# GZEM1405002201RF Modification Method

**Product Name: 4WD High Speed Remote Control car**

Product NO.: RP-01

## Field Strength of Fundamental & Field Strength of Unwanted Emission

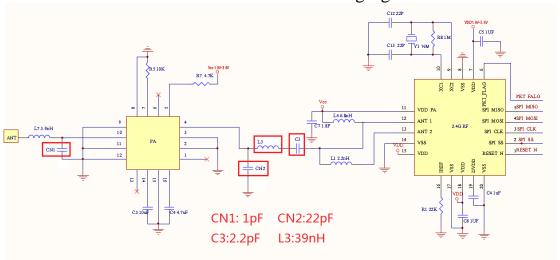
1. Add two capacitors CN1, CN2 and replace the capacitor C3 and the inductor L3 for the transmitter as the following figure shown.
